STAFF REPORT
COMMUNITY DEVELOPMENT DEPARTMENT

DATE: 10/22/2024
TO: City Council
FROM: Sonya Allen, Associate Planner
208-884-5533
SUBJECT: FP-2024-0001
Promenade Cottages No. 1
PROPERTY LOCATION:
403 E. Fairview Ave., in the NW 1/4 of
Section 7, T.3N., R.1E.

Final plat consisting of 30 single-family residential building lots and five (5) common lots on 2.7-acres of land in the R-40 zoning district for the first phase of Promenade Cottages Subdivision.

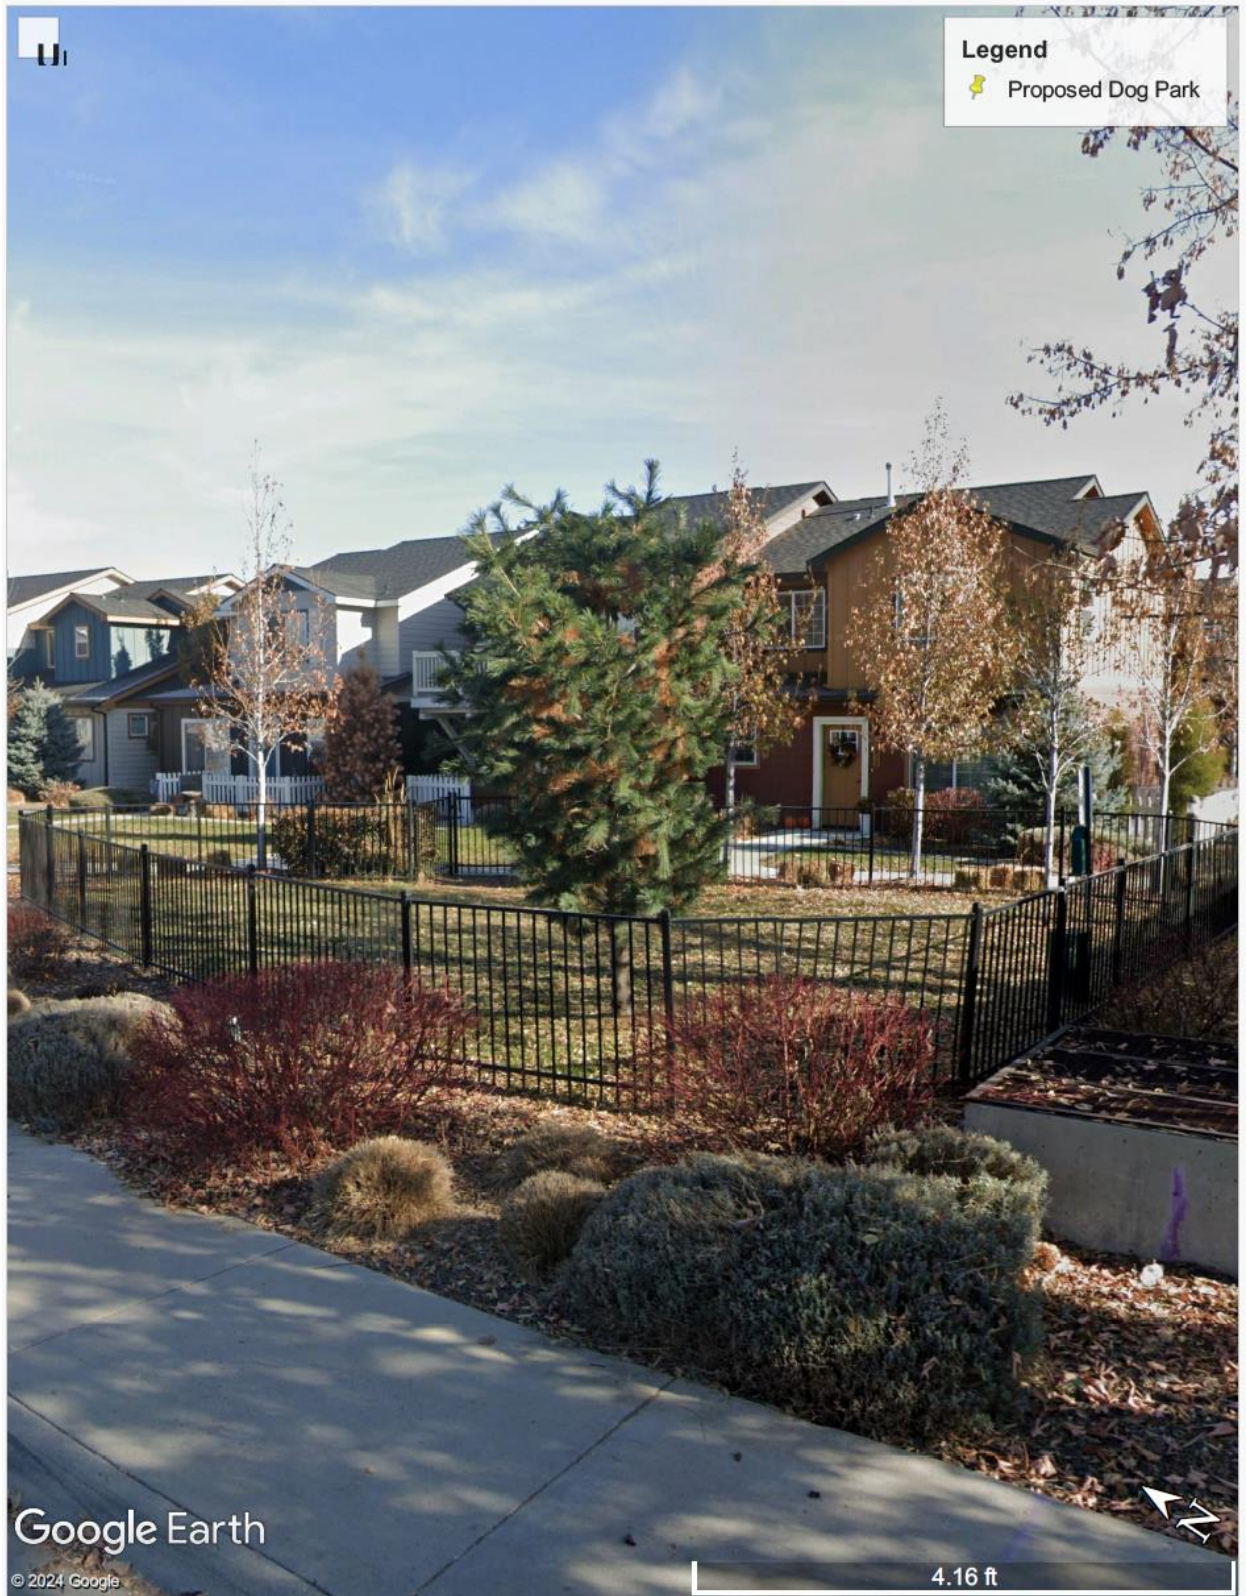
- d. Depict zero (0) lot line setbacks where attached dwellings span across lot lines.
5. The landscape plan prepared by The 3 Brothers Landscaping Co., dated 1/31/24 included in Exhibit C, shall be revised as follows: *(Note: The version of the UDC that applies is Nov. 30, 2021)*

- a. The landscape plan is required to be prepared by a landscape architect, landscape designer or qualified nurseryman per UDC 11-3B-3D; specify on the plan which applies.

- b. In the Landscape Calculations table, include the linear feet of frontage on NE 3rd St. and the required number of street trees that demonstrate compliance with the standards listed in UDC [11-3B-7C.3](#).

- c. Depict landscape materials within the street buffer along NE 3rd St. in accord with the standards listed in UDC [11-3B-7C](#).
 - d. In the Landscape Calculations table, include the linear feet of pathways within the site and the required number of trees that demonstrate compliance with the standards listed in UDC [11-3B-12C](#).

- e. Depict landscape materials adjacent to all pathways within the site that demonstrate compliance with the standards listed in UDC [11-3B-12C](#).
 - f. Include mitigation information on the landscape plan for all existing trees that are being removed with development in accord with the standards listed in UDC [11-3B-10C.5](#).

- g. Depict pedestrian lighting adjacent to the pathway along the eastern boundary of the subject property.

- h. Depict pedestrian connections between the subject property and the multi-family development to the north. All pathways should comply with the standards in UDC 11-3A-8.
